Subject: Construction of New Campus of Punjab Technical University-18<sup>th</sup> Meeting of the Standing Building Construction Committee.

**Subject:** Agenda for the 18th Meeting of the Standing Building Construction Committee.

Minutes of the Meeting held on 22.10.2007 in the Central Road Research Institute, Delhi regarding construction of parking:

60 MM TH. PAVER OVER  
25 MM TH. DRY SAND LAID  
OVER BITUMINOUS BASE  
OF MIXED SEAL OVER  
75 MM TH. CRUSHED STONE AS/SPEC  
OVER 75 MM TH. GAUSE STONE  
AS/SPEC. COMPACTED OVER  
150 MM TH GRANULAR BASE  
COMPACTED IN TWO LAYERS  
OVER RAMMED EARTH.

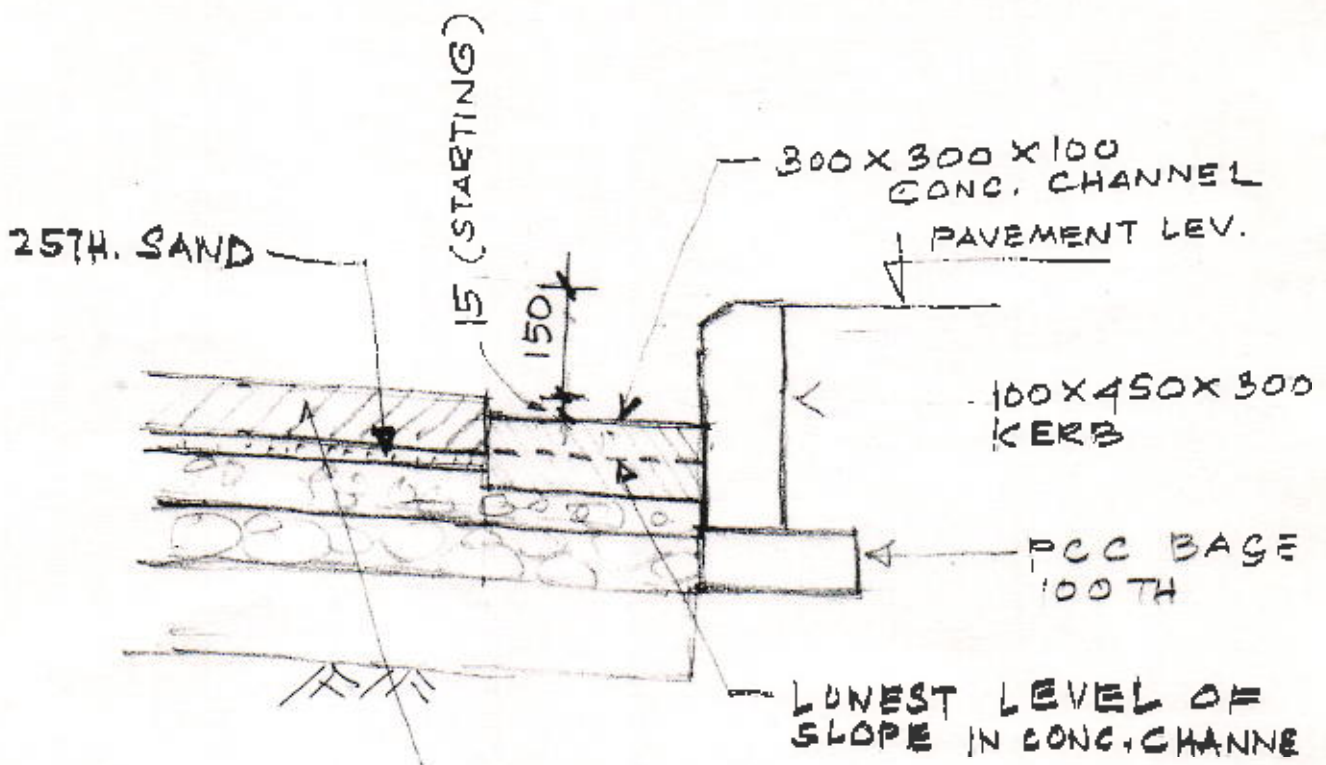
- b) The proposal mentioned above was discussed in detail CRR I scientists and they remarked that the proposed design and specifications are ok for the intended use. However, following may be kept in view:

- shape of paver should be similar to C of category A on page 7 of the IRC:SP:63-2004 for better interlocking;
  - granular sub base may be extended by 500mm where possible for better drainage;

- laying of pavers is a skilled job and the sub contractor should be approved keeping this fact in view;
  - moist coarse sand with water content of 8-10% should be used. The pavers laid over this sand may be lightly vibrated with light capacity plate vibrator;

- no paver should have 28 days strength less than 40KN;
- c) Involvement of CRR I shall be after the laying of WBM and when the laying of pavers is taken up. The team of the CRR I shall conduct 2 visits.
